**Project #20-002**  
**Dr. Harris Urgent Care Center**  
**Located at 939 S Hwy 89/91**

*Project Name:* Dr. Harris Urgent Care Center  
*Proponent / Owner:* Matthew F. Harris / Stronghold Opportunity Fund LLC  
*Project Address:* 939 S Hwy 89/91  
*Request:* Design Review Permit  
*Current Zoning:* Commercial (COM)  
*Type of Action:* Quasi-Judicial  
*Hearing Date:* January 9, 2020  
*Submitted By:* Aaron Smith, Planner II

1	Proposed Site Plan -
2	939 South Main
	1/32" = 1'-0"

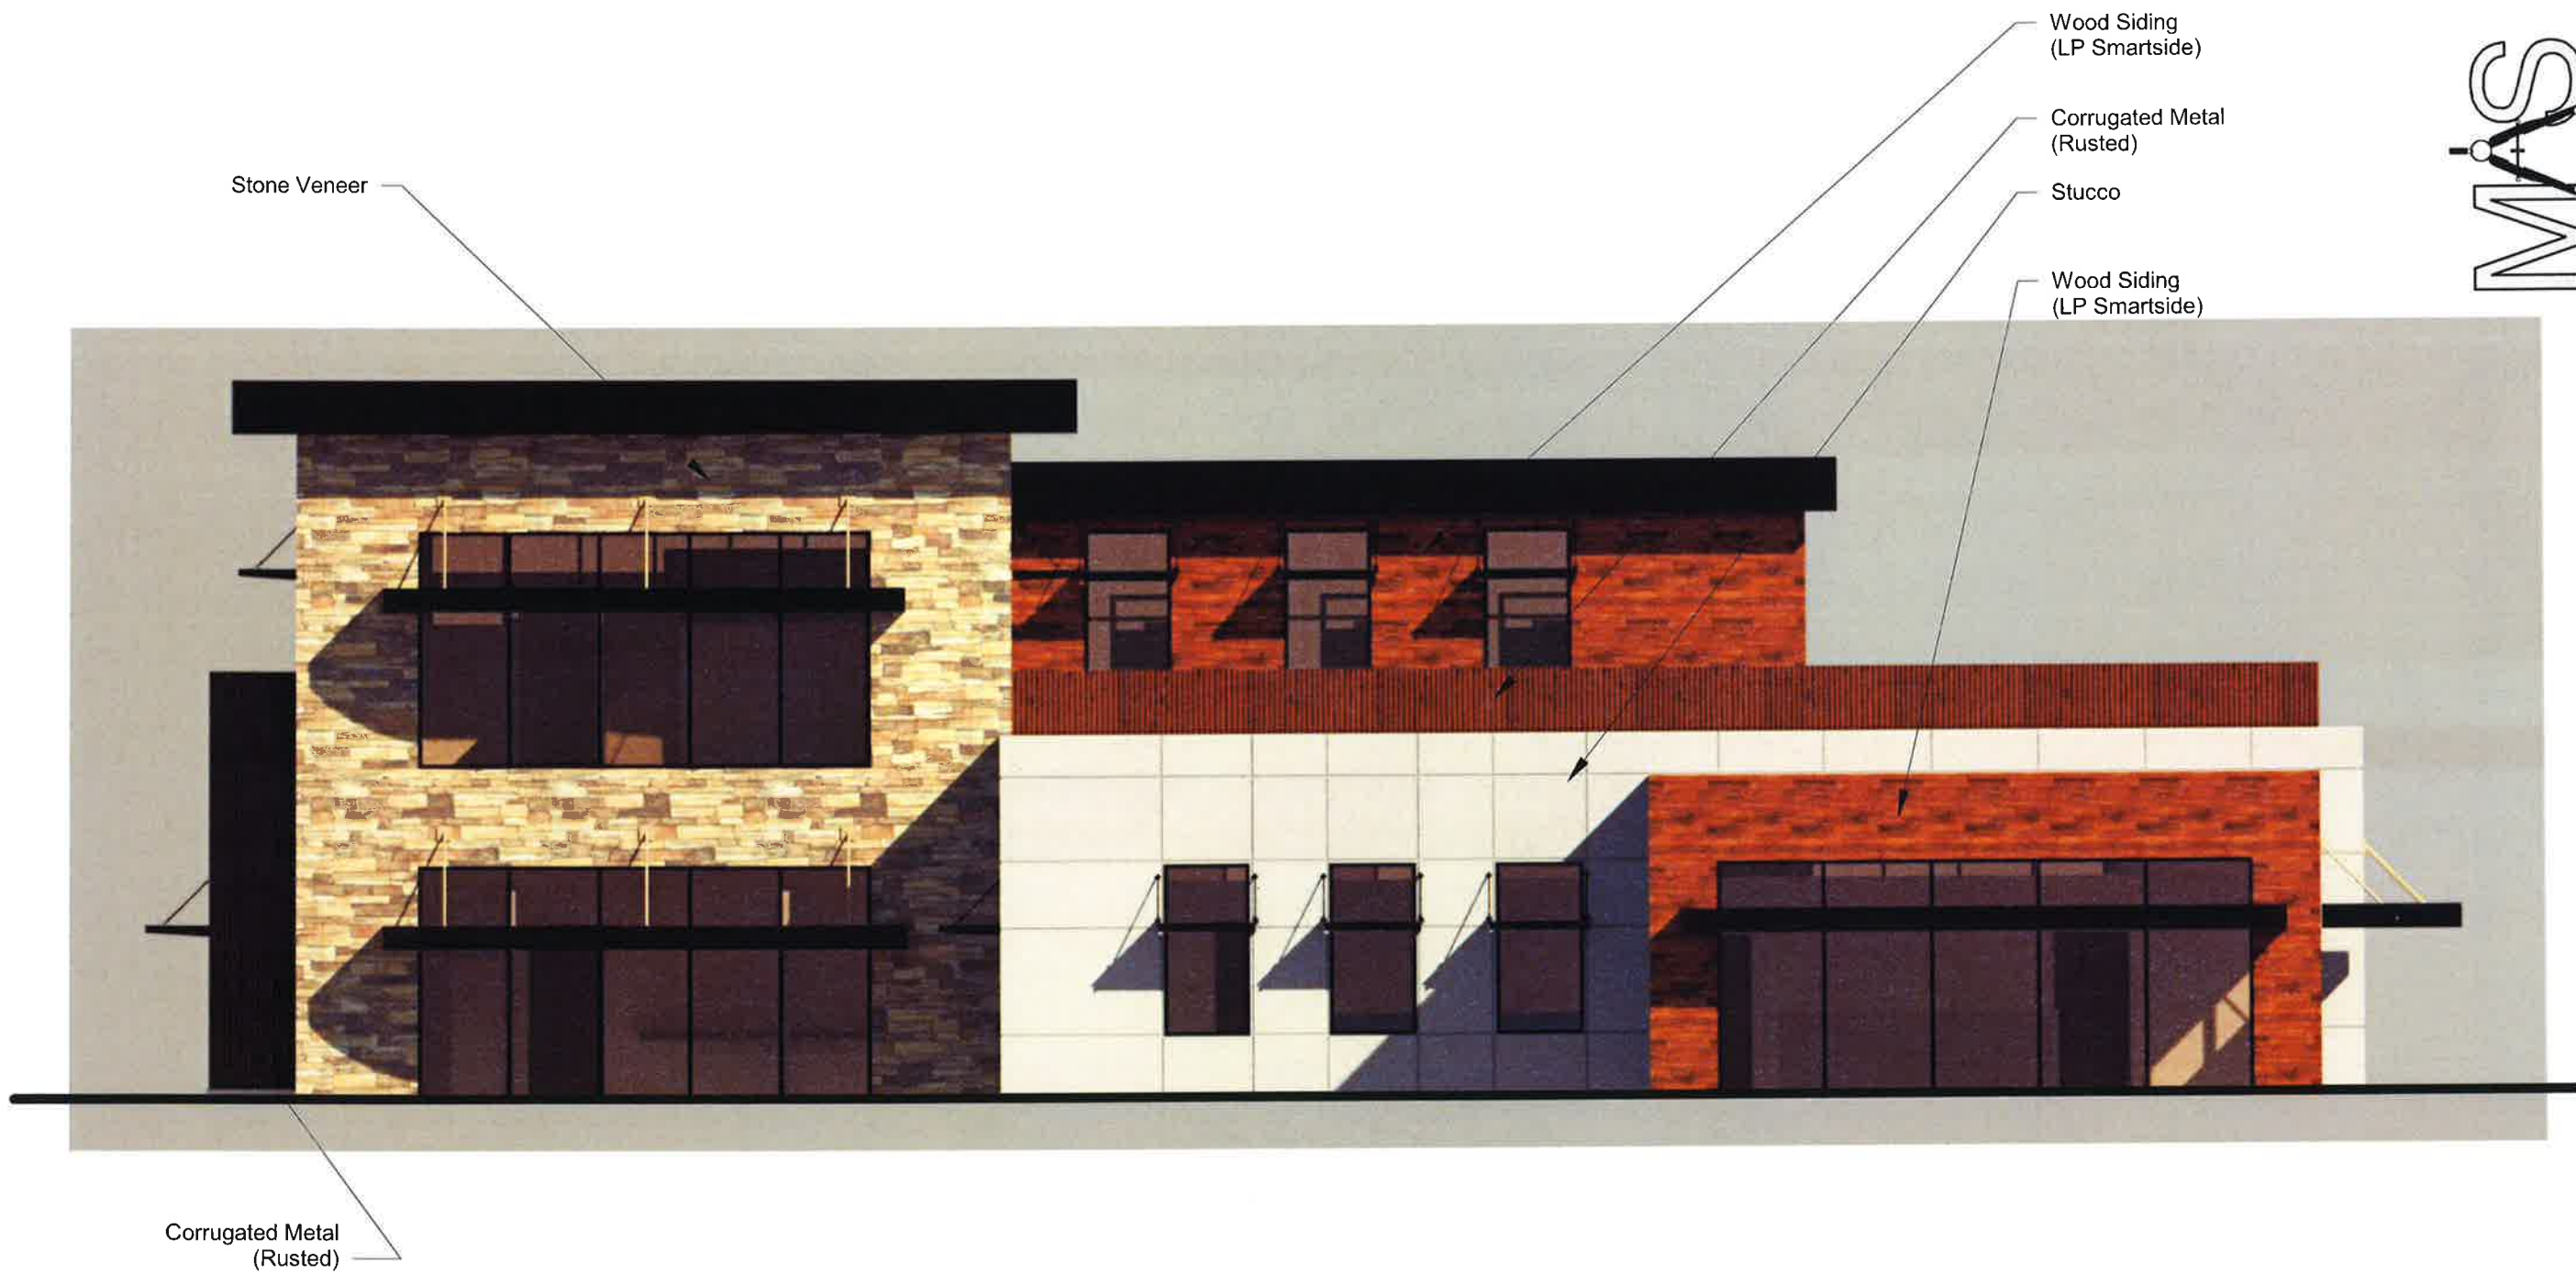
The COM zone lot coverage is limited to a maximum of 60% (building footprint). The footprint of the proposed building is 10,500 SF and the remaining storage building is 10,300 SF. The total building coverage on the site is 30% for the entire parcel. As proposed, the project complies with the requirements in the LDC.

The Commercial zone requires a minimum 50% building frontage at the front setback. The parcel has 228' of frontage and 123' of building located along the frontage (53% building frontage at front setback). As proposed, the project complies with the requirements in the LDC.

Front (East):	10'
Side (South):	8'
Side (North):	78'
Rear (West):	126'
Parking Side (South):	5'

Vehicular driveway access from Hwy 89/91 is via an existing shared drive on the northside of the property. The proponent is also working with the landowner to the south to establish a second access to the highway. The project proposes a pedestrian access point from the commercial building to the sidewalk along the northside of the building. As proposed, the project complies with the requirements in the LDC.

The proponent is working to meet the parking requirement through obtaining off-site parking on the adjacent property to the south. To meet the parking requirements, 15 additional off-site parking stalls would need to be obtained. The adjacent land uses would be required to maintain their minimum parking requirements. Staff's review of the parking requirement for current uses in the two buildings to the south is 20 for the 5,000 SF retail building and 8 for the 4,000 SF wholesale and service and service building. To meet the requirements of the LDC an Alternative Parking Plan would be submitted for review and approval to Community Development staff, in accordance with requirements of the LDC, that outlined the parking agreement between the properties, and demonstrated that minimum parking requirements are being met for all uses.

Generally, surface storm-water retention and detention facilities should not be located in front yard areas. The proposed plan includes an area of retention in the northeast portion of the site adjacent to the highway. Retention basins that are located in areas that are visible from the public street are required to be landscaped to provide an amenity to the development and utilize landscaping materials that reflect the natural traditions of Logan. As conditioned, with a landscaped retention area, the project complies with the requirements of the LDC.

Interior parking lot landscaping is required. The site plan proposes new parking lot landscaping areas. These areas are required to have a minimum of 2 trees and a 50% plant material coverage at plant maturity. The LDC requires that all parking aisles have a landscaped area at the end of every aisle. Interior parking lot landscaping requirements shall be incorporated into the landscaping plan.

1. All standard conditions of approval will be recorded with the Design Review and are available in the Community Development Department.
2. A minimum of 55 parking stalls are required, or, if off-site parking is proposed to meet the minimum parking standard, an Alternative Parking Plan shall be provided and approved by the Community Development Director per the requirements of LDC 17.31.050.

- a) A minimum of 3,500 SF of both open space and usable outdoor space, for a total of 7,700 SF, shall be provided
  - b) A total of 18 trees and 45 shrubs, flowers and ornamental plants shall be provided.

- f) Interior parking lot landscaping areas are required to have a minimum of 2 trees and a 50% plant material coverage at plant maturity.
  - g) Surface storm-water retention and detention facilities that are located in areas that are visible from the public street shall be landscaped to provide an amenity to the development and utilize landscaping materials that reflect the natural traditions of Logan.

2	<b>East Elevation</b>
3	1/8" = 1'-0"

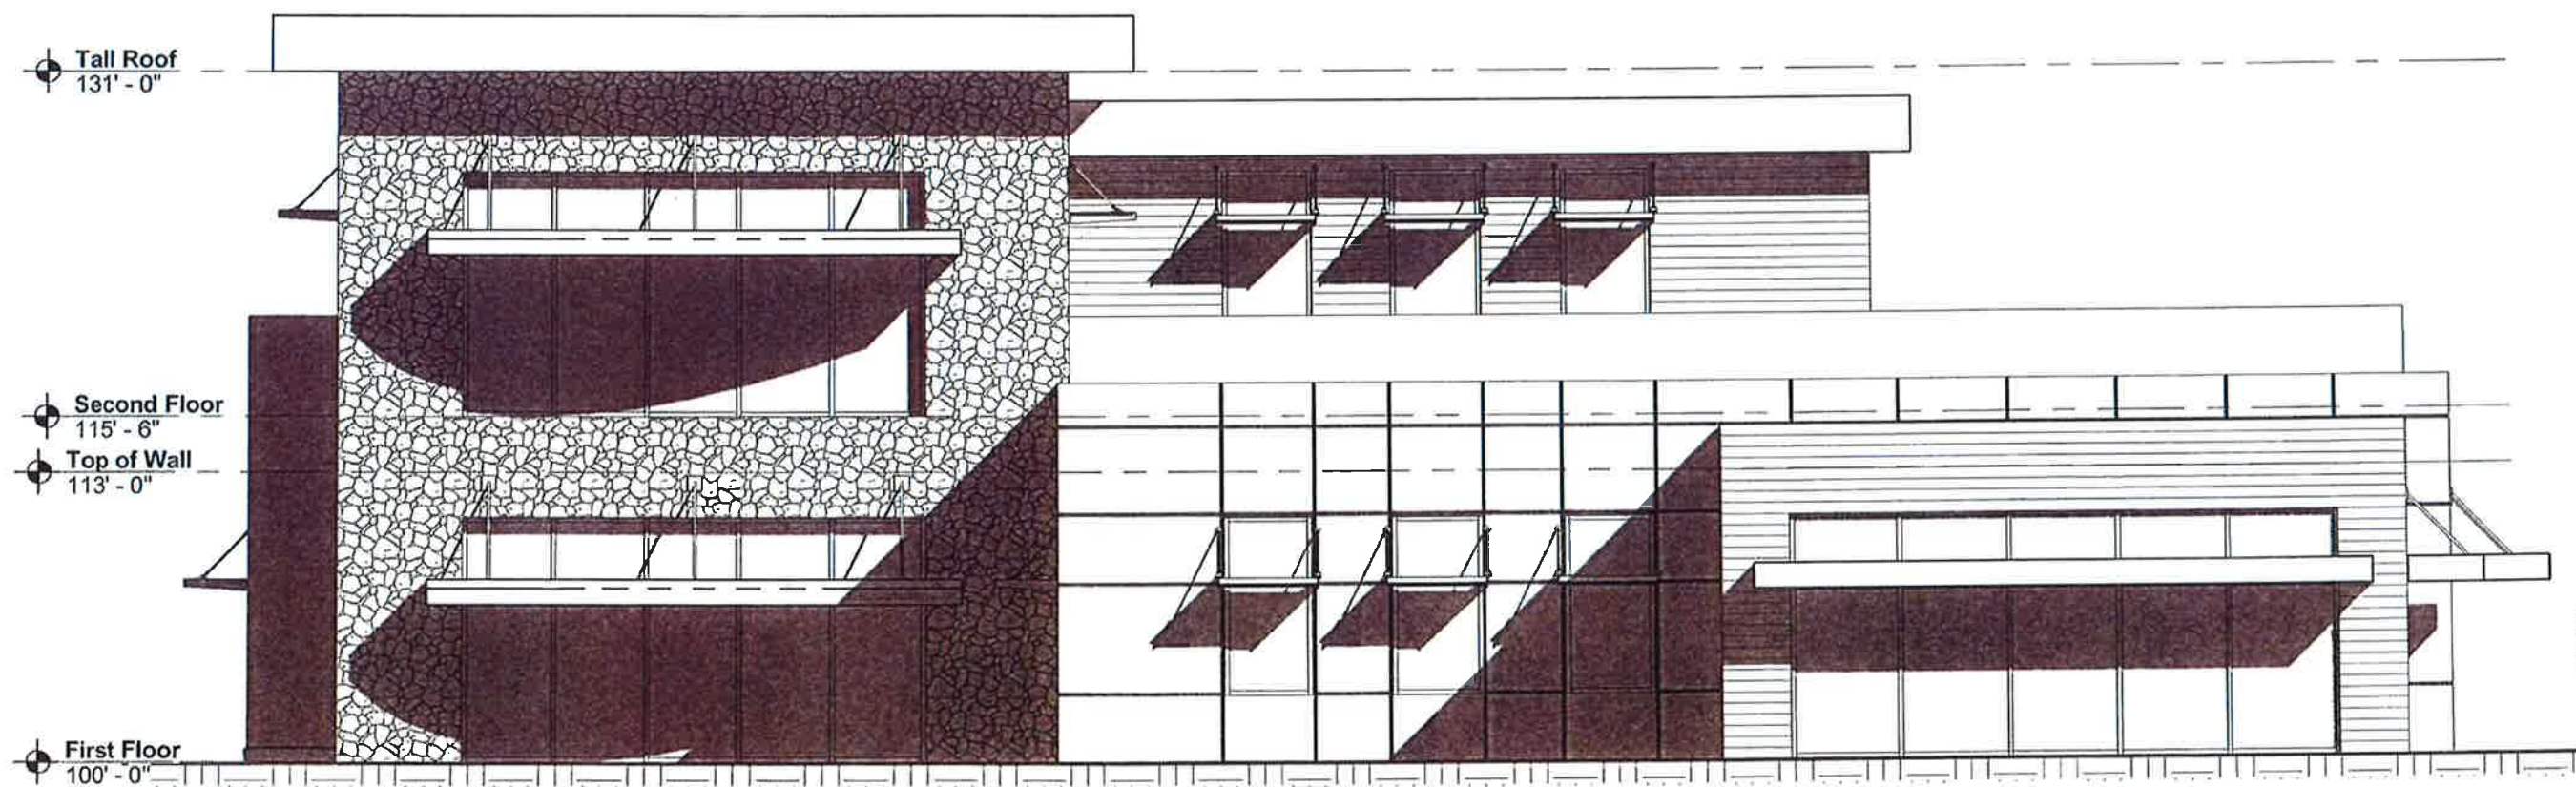
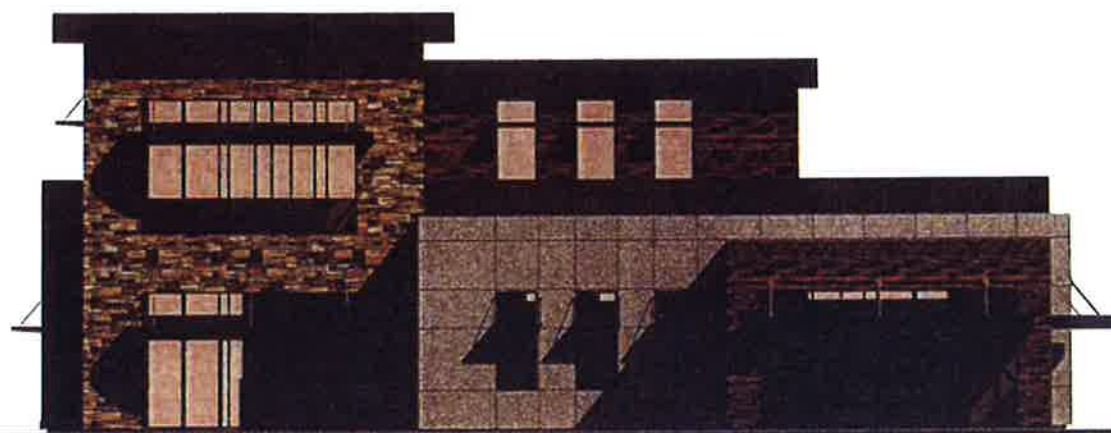
East Elevation (Hwy 89/91):	49%
North Elevation (Towards Parking):	45%
West Elevation (Towards Parking):	39%
South Elevation:	27%

As proposed the project is not on a corner, the south elevation would not be considered an exposed side. Overall, the project has generous fenestration. As proposed, the project complies with the requirements in the LDC.
